UNITED STATES PATENT AND TRADEMARK OFFICE

10/628,588

Office Action Summary	Application No. 10/628,588	Applicant(s) DROGUE ET AL.	
	Examiner MICHAEL G. BOGART	Art Unit 3761

DETAILED ACTION

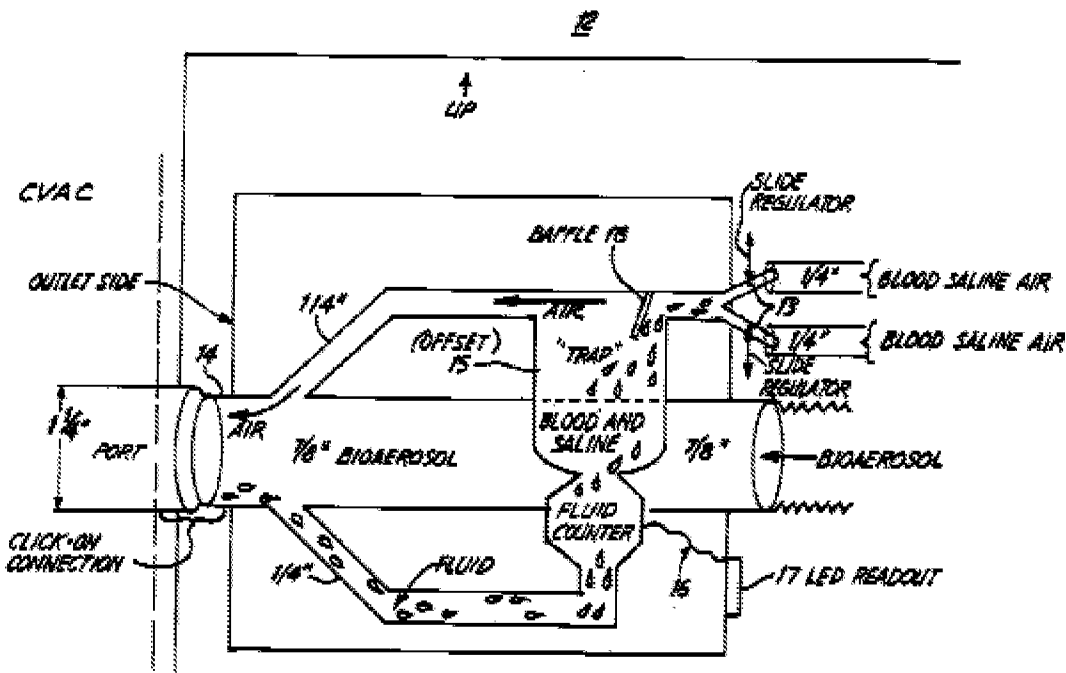
Claim 43 recites an air pathway from the inlet to the separation chamber and a fluid pathway from the inlet to the separation chamber, the fluid pathway being separate from the air pathway. The instant invention only discloses a single pathway from any of the individual inlets (13) to the separation chamber (15)(see applicant's figure 2, *infra*).

Fig. 1

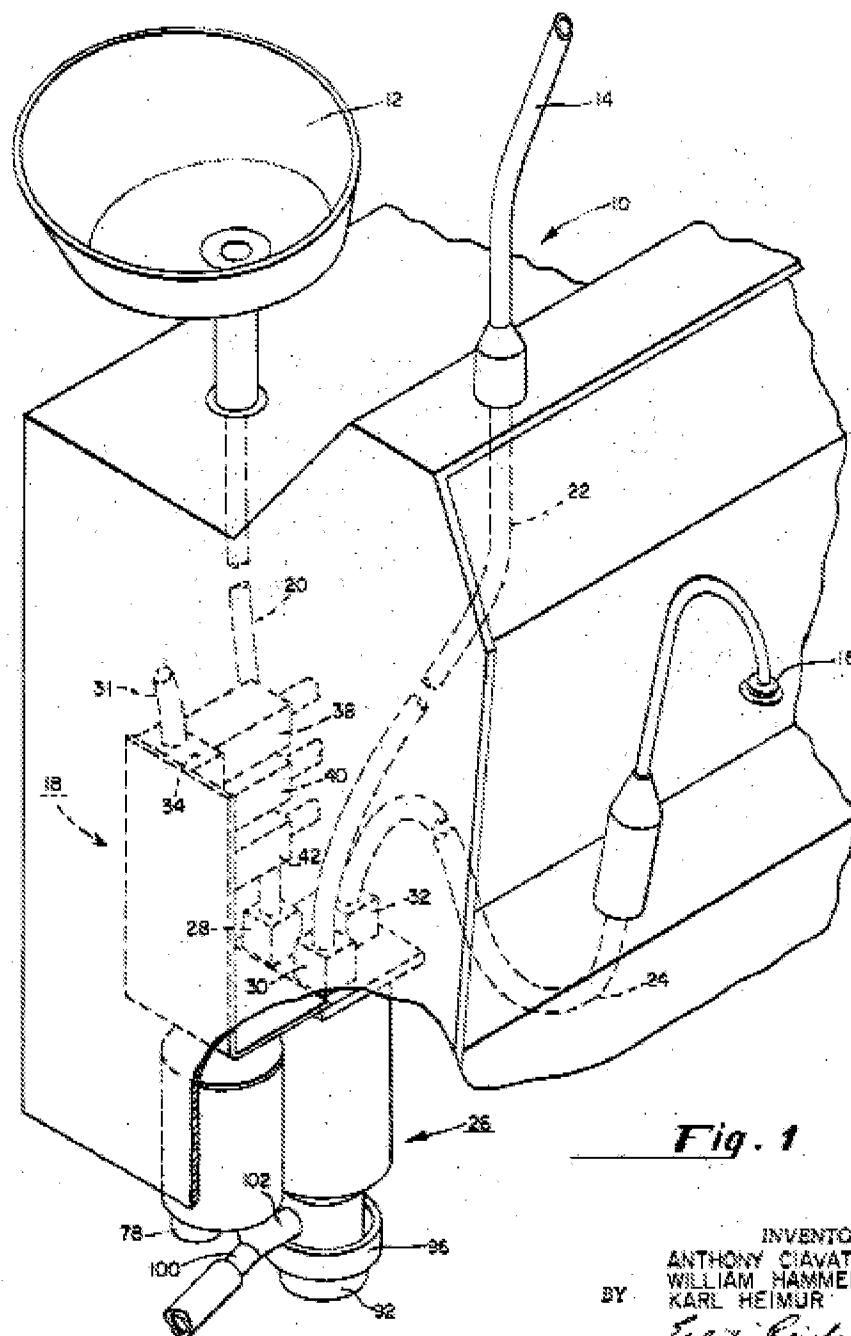
a removable decontamination unit (70) capable of being coupled to the connector (54, 68)(col. 2, line 69-col. 3, line 25)(see figures 1, annotated figure 2, and figure 5, *infra*).

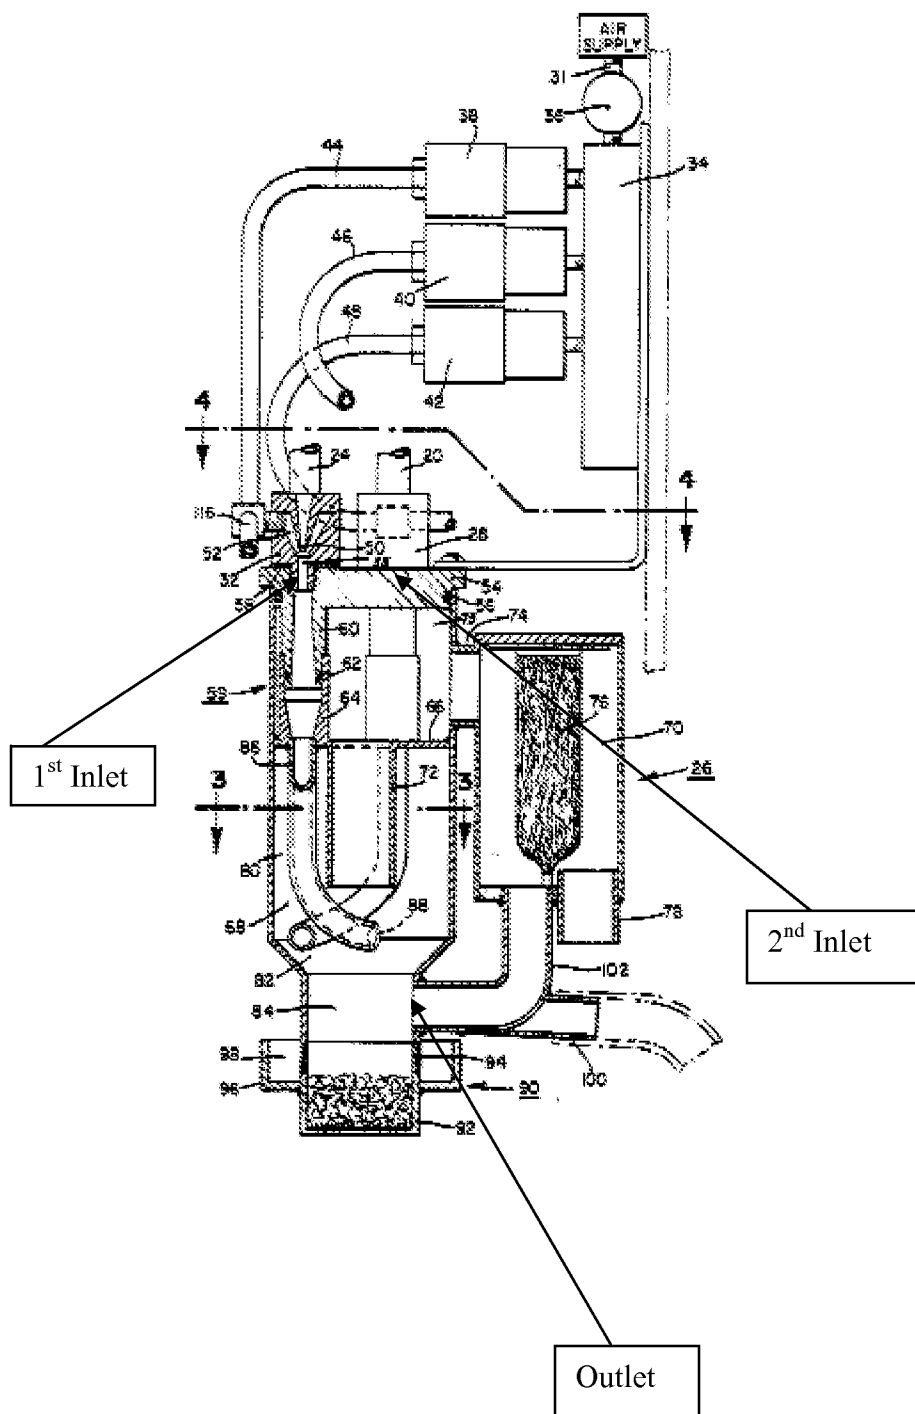
a connector (54, 68) comprising an inlet, an outlet in communication with the vacuum source (28, 30, 32), a separation chamber (68) in communication with the inlet, an air pathway (72, 73, 74, 70, 78) in communication with the separation chamber (68) and the outlet, and a fluid pathway (100) separate from the air pathway (72, 73, 74, 70, 78) and in communication with the separation chamber (68);

Regarding the outlet being in communication with the vacuum source (28, 30, 32), Ciavattoni teaches that the vacuum source (28, 30, 32) is in fluid communication with the outlet as indicated in annotated figure 2, *infra*.

a removable decontamination unit (70) capable of being (fluidically) coupled to an inlet of the connector (54)(see annotated figure 2, supra).

Regarding the limitation where the outlet is operably connected with the vacuum source, the outlet is in fluid communication with the vacuum source provided at venturi (28) and lines (20). A positive pressure of air flows unimpeded from venturi to the outlet.

5. Applicants assert that Ciavattoni does not disclose a connector comprising an outlet in communication with the vacuum source. Applicants further assert that Ciavattoni's vacuum source is located in the pathway prior to the inlet. This argument is not persuasive because the instant invention does not require a vacuum source at or downstream of the inlet of the separation chamber. Ciavattoni does indeed teach an outlet in fluid communication with the vacuum source as there is nothing to impede fluid communication of fluid from the inlet to the outlet (see annotated fig. 2, *supra*).

This argument is not persuasive because Ciavattoni's exhaust unit (70) can be removed from the rest of the device at least by disconnecting or severing lines (74) and (102)(see fig. 2).

9. Applicants assert that neither Ciavattoni, Goosen or Walker disclose a decontamination unit adapted to be coupled to a connector. This argument is not persuasive because Ciavattoni teaches an exhaust unit (70) that is coupled to a connector (54, 68)(see fig. 2).

FIG. 2

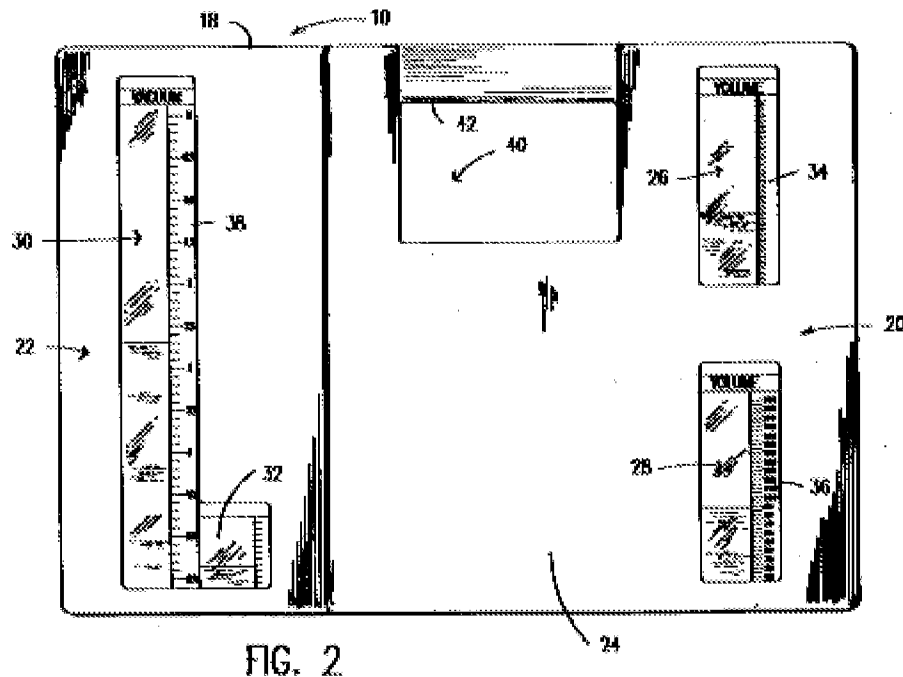
Regarding claim 38, Goosen teaches a flow volumetric flow indicator (26)(figure 2, *infra*).

At the time of the invention, it would have been obvious to one of ordinary skill in the art to add the flow indicator of Goosen to the evacuation apparatus of Ciavattoni in order to provide a means of monitoring the flow rate of the system.

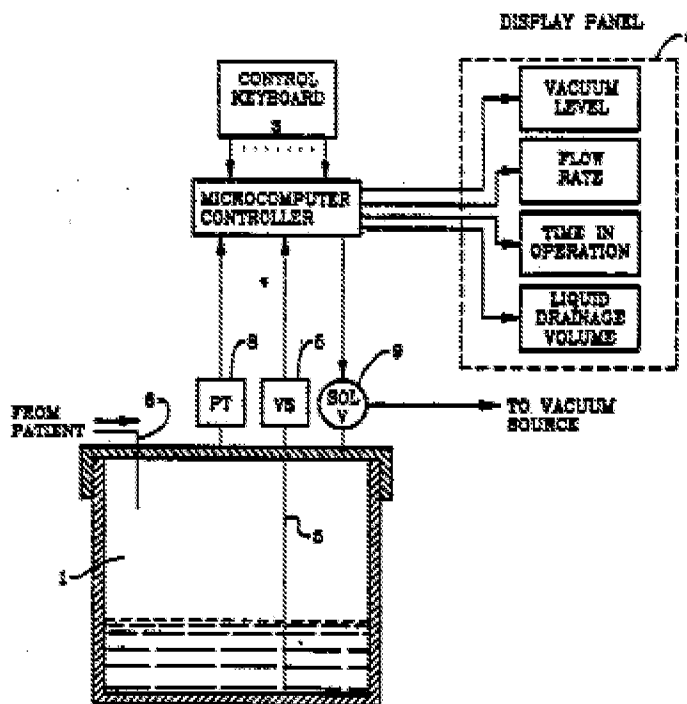
Walker teaches a keyboard (3) for controlling a medical suction apparatus (see figure 1, infra).

At the time of the invention, it would have been obvious for one of ordinary skill in the art to add the keyboard of Walker to the evacuation apparatus of Ciavattoni in view of Goosen in order to provide a means of controlling the air pressure and vacuum applied to a patient. See *Ex Parte Smith*, supra.
